# UNITED STATES PATENT AND TRADEMARK OFFICE

APPLICATION NO.	FILING DATE	FIRST NAMED INVENTOR	ATTORNEY DOCKET NO.	CONFIRMATION NO.
09/954,994	09/18/2001	Sven K. Esche	SIT-0106	2909
26259	7590	02/21/2006	EXAMINER	
LICATLA & TYRRELL P.C. 66 E. MAIN STREET MARLTON, NJ 08053			BURCH, MELODY M	
			ART UNIT	PAPER NUMBER
			3683

# Office Action Summary

## **DETAILED ACTION**

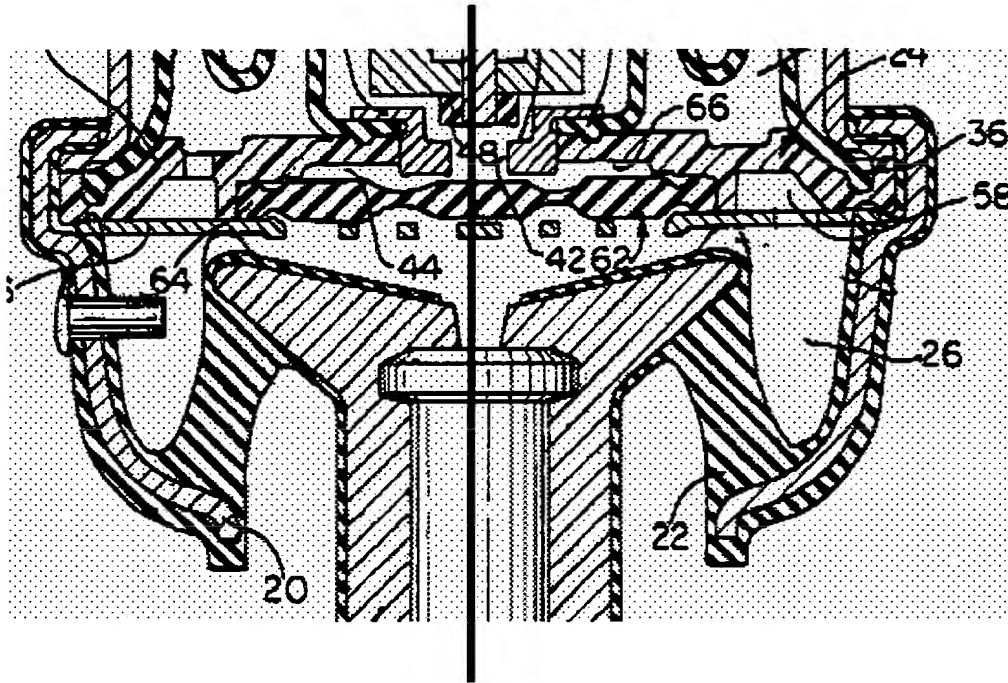
With regards to claim 2 Applicant argues that the means for controlling the preload 22 is not independent of the rod 18. Examiner disagrees. As broadly claimed, elements 18 and 22 are independent by the mere fact that they are two distinct elements. The fact that element 22 can move without causing movement of element 18

in the arrangement set forth in JP'725 also suggests that the two elements are independent.
